**Report to
Development Permit Panel**

To: Development Permit Panel
From: Holger Burke,
Acting Director of Development
Date: August 24, 2005
File: DP 05-298114
Re: **Application by Timothy Tse/Woodridge Developments for a Development Permit at 7751 Acheson Road**

PLAN #1 - SITE PLAN - SETBACKS

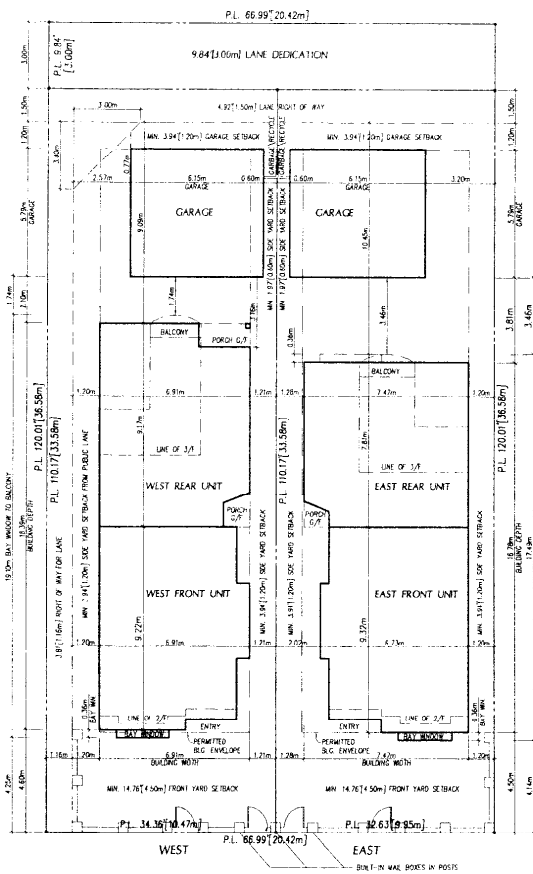
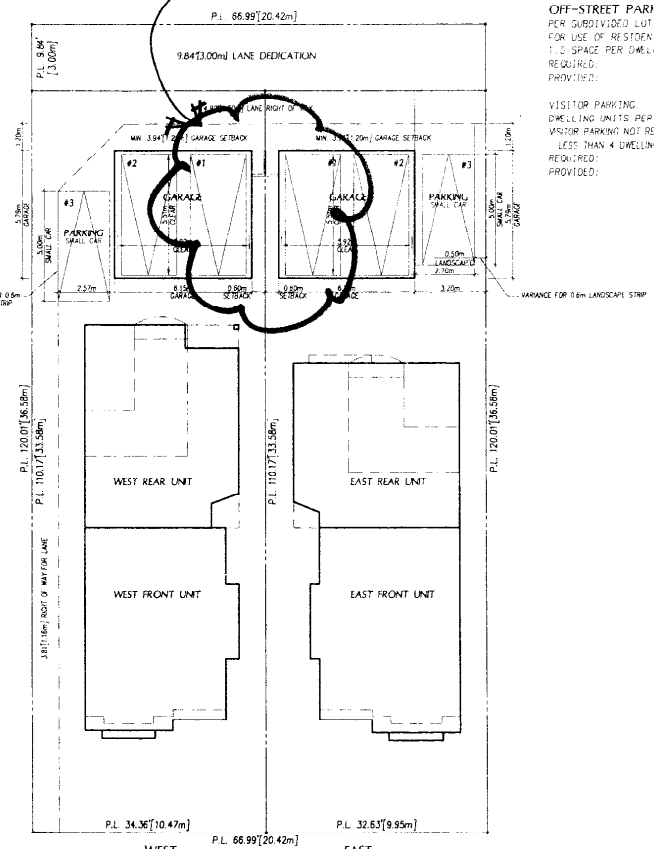
- Reduce the side yard setback for the proposed garage from 1.2 m to 0.6 m along the common property line. **Staff recommend support for this variance due to the nature and extent of the lane dedications and right of way required. Similar garage setbacks have been provided at other locations in the immediate area e.g., 7860 Bennett Road (DP 04-270199) and 7920 Bennett Road (DP 04-268922). The setback variance is also required to accommodate the parking pad.**

PLAN #3 - LANDSCAPE PLAN

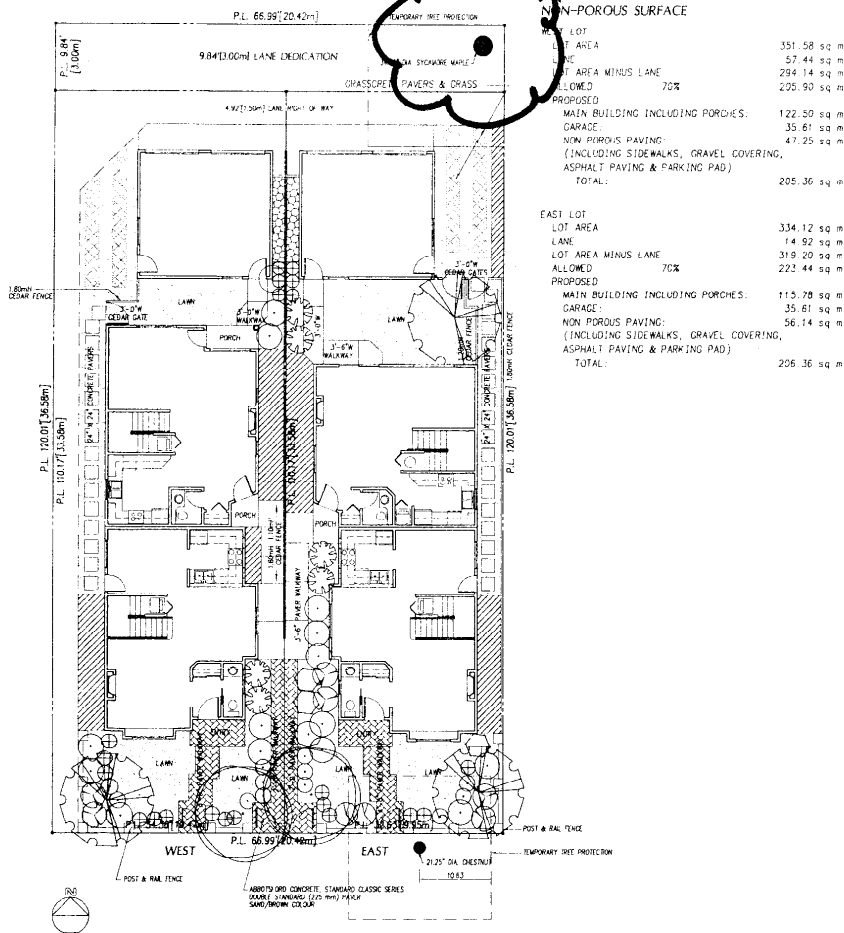
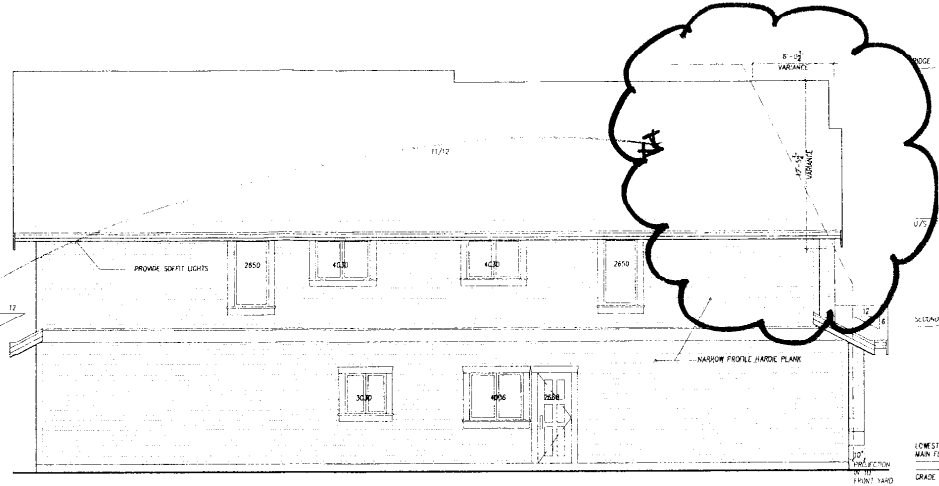
- An arborist's report and replacement criteria based on the health and viability of retention: tree retention and protection are noted on Landscape Plan (Sheet No. 3);
- A tree replacement rationale and tree replacement table: 2:1 tree replacement ratio required. An approximate 1:1 ratio has been provided with five - 8 cm calliper trees. A cash-in-lieu payment of \$3750 is to be paid to the Parks Development Fund by the developer for the balance of the 2:1 replanting equivalent of the tree replacement ratio; and
- An improved streetscape and liveability of the front yards due to increased specimen size: 8 cm calliper trunk diameter in major specimens, 5-7 cm calliper trees in other select species.

- The landscape plan includes a re-planting scheme with tree replacement rationale and table that will integrate well with the existing streetscape;
- Tree retention includes the mature chestnut tree to the Acheson Road boulevard;
- Side-yard fences along the property line will be 1.8 m; front yard fences along the property line will be 1.2 m fences;
- Grasscrete pavers with grass are to be utilized for the wheel strips in parking areas. These materials will improve the permeability of the site;

PLAN #5 – SIDE ELEVATIONS OF WEST BUILDING

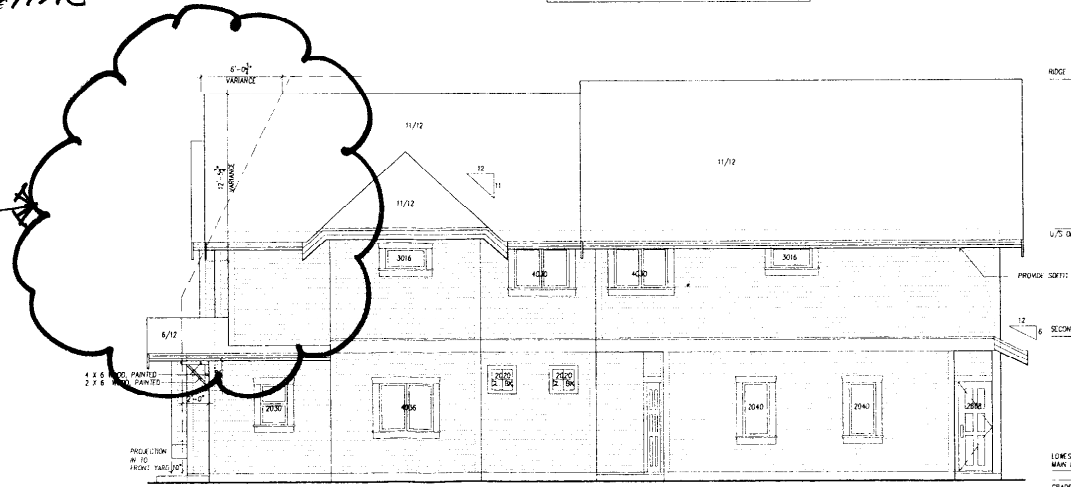
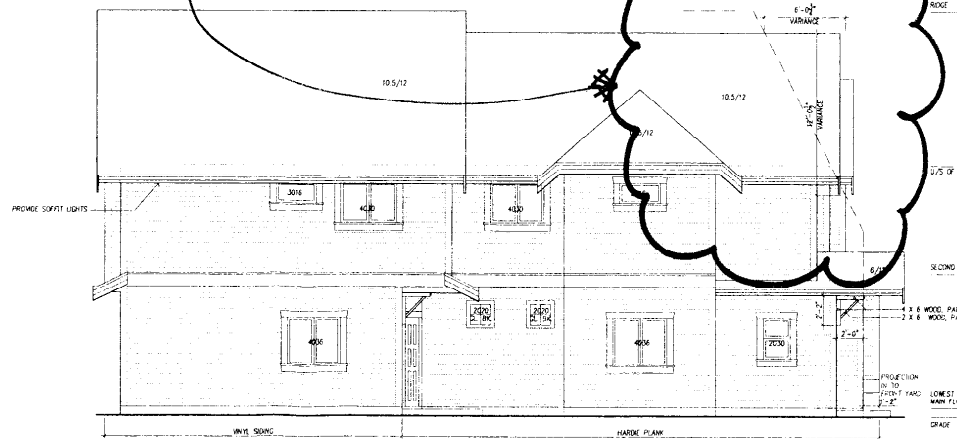
- Permit the attic gable end and bay windows to project approximately 1.8 m horizontal and 3.7 m vertical beyond the residential vertical envelope to Acheson Road. **Staff recommend support for this variance to maintain consistency with roof pitches and gables in the recent developments to the west, and to increase interest and articulation along the streetscapes (adjacent to the subject site) and along Acheson and Bennett Roads.**
